**PM5362**

**SONET/SDH TRIBUTARY UNIT PAYLOAD PROCESSOR /  
PERFORMANCE MONITOR**

**DATA SHEET ERRATA**

**ISSUE 4: NOVEMBER 2000**

### 1.1 Device Identification

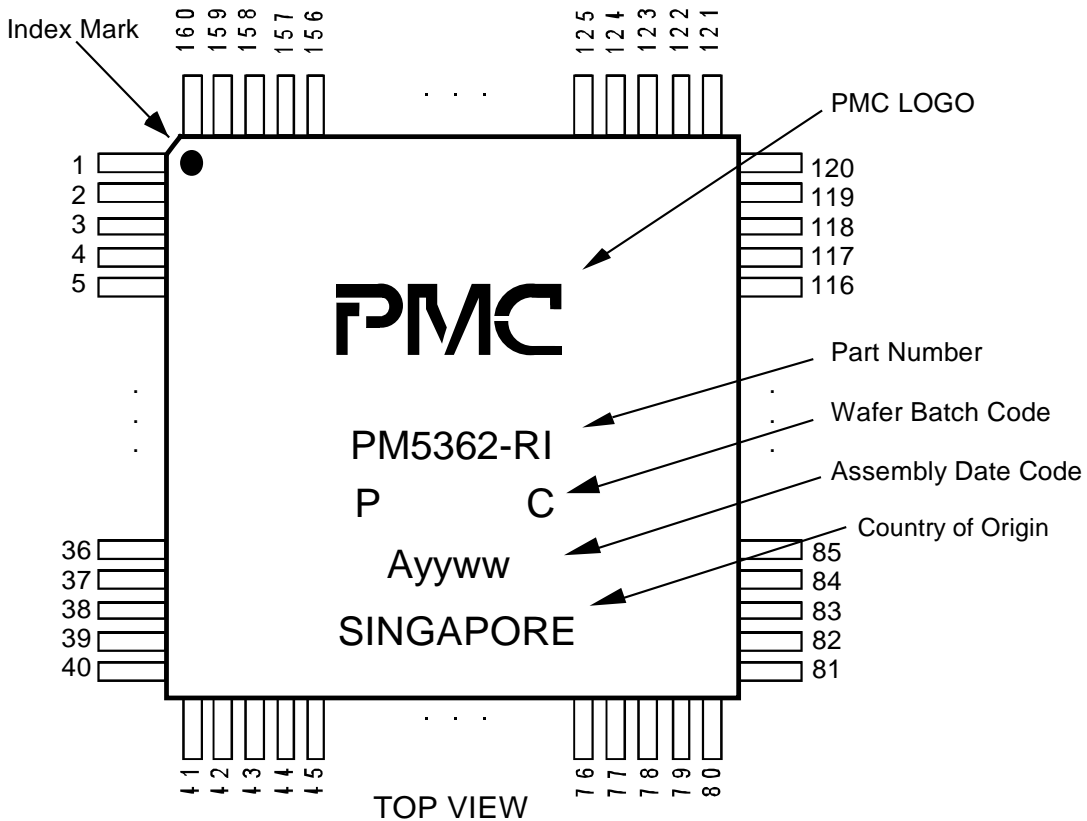
The information in this document applies only to the PM5362 TUPP-PLUS Revision C device. The device revision is marked at the end of the wafer batch code on the face of the device.
